New Albany Planning Commission Agenda

Monday, December 20, 2021 7:00pm

Planning Commission Staff Report November 15, 2021 Meeting

LOCATION:	7270 New Albany-Condit Road (PID: 222-001945)
APPLICANT:	Cornerstone Academy c/o Aaron Underhill, Esq.
REQUEST:	Zoning Amendment
ZONING:	Limited General Employment (L-GE) to Infill Planned Unit Development (I-
	PUD)
STRATEGIC PLAN:	Employment Center
APPLICATION:	ZC-105-2021

NEW ALBANY, OH NEW ALBANY, OH
CONCEPTUAL SITE PLAN CONCEPTUAL SITE PLAN No. DATE REVISIONS DESCRIPTION No. DATE REVISIONS DESCRIPTION No. DATE REVISIONS DESCRIPTION 2021 2021 2021 2021 2021 2021 2021 2021
CONCEPTUAL SITE PLAN
CONCEPTUAL SITE PLAN
1 1 1 4

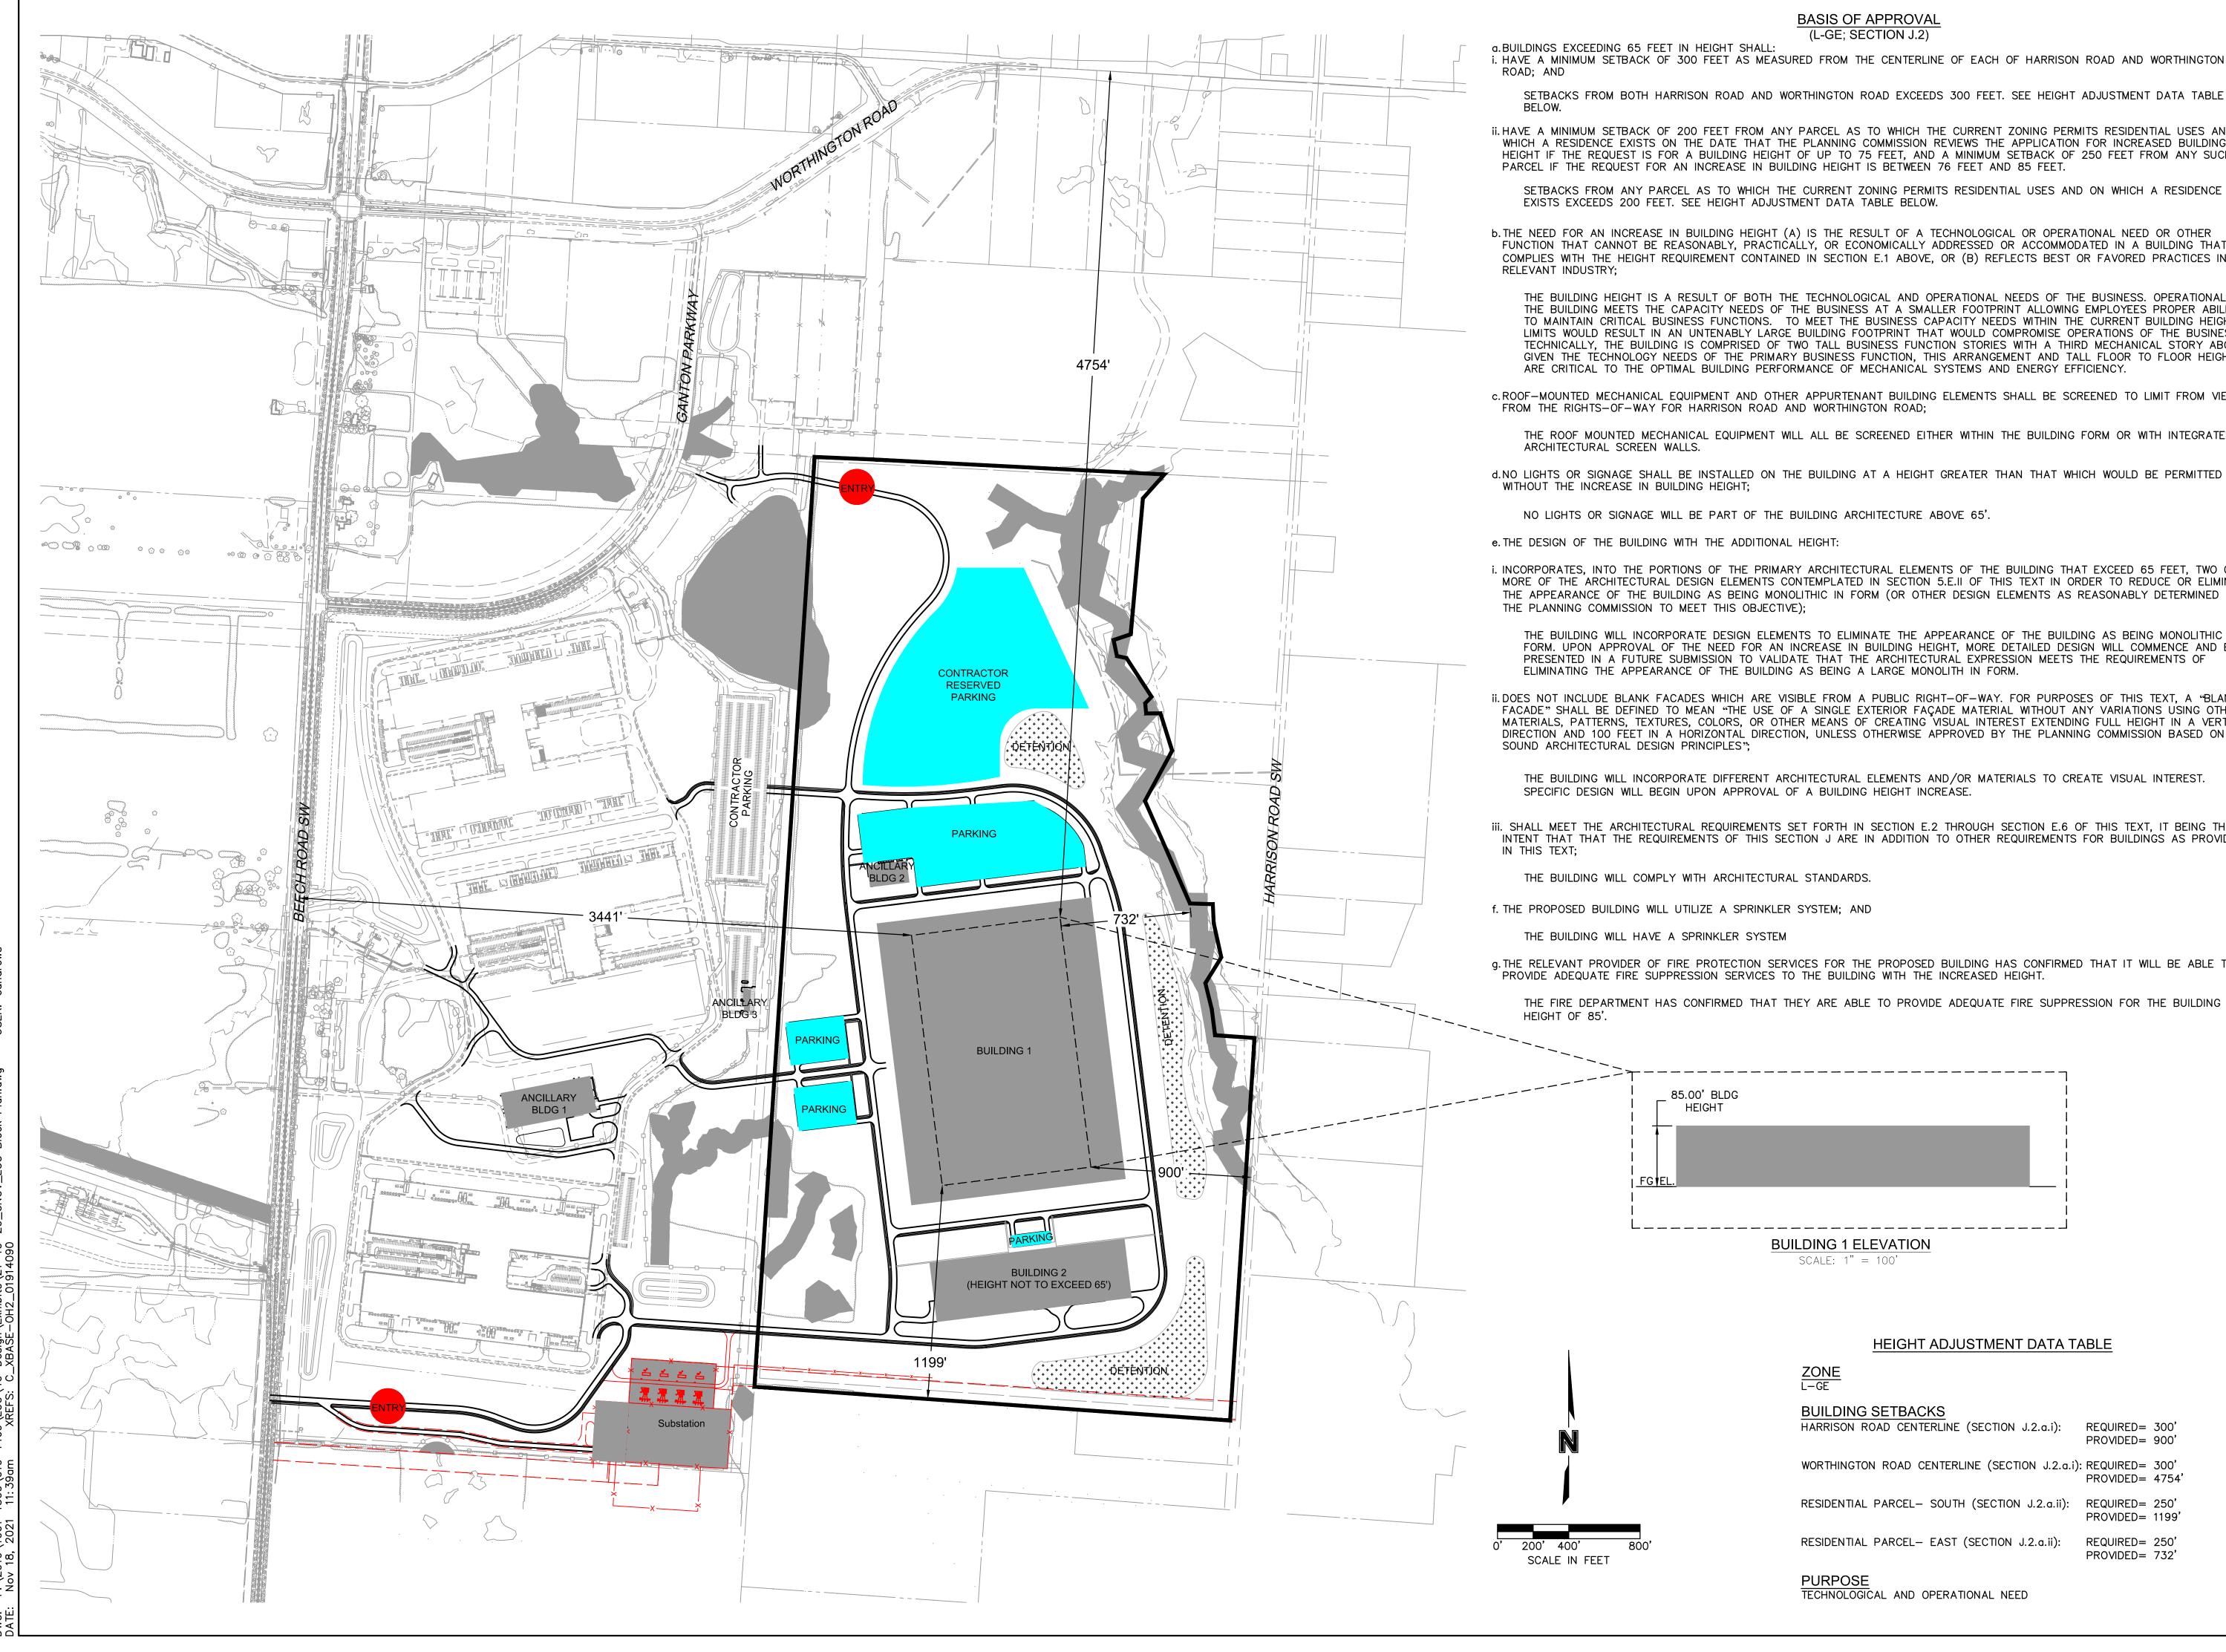
Staff recommends approval of the height adjustment application. The applicant has provided sufficient information to ensure that the additional requirements of the zoning text will be met with a taller building height. A second layer review of these requirements will also occur during the construction permit review process for the project by city and fire department staff. Additionally, variances have been approved by the Board of Zoning Appeals in the immediate area to remove height limitations for similarly zoned properties so the 85-foot building height is consistent with surrounding zoning requirements.

Move to approve application ARB-127-2021 (conditions of approval may be added).
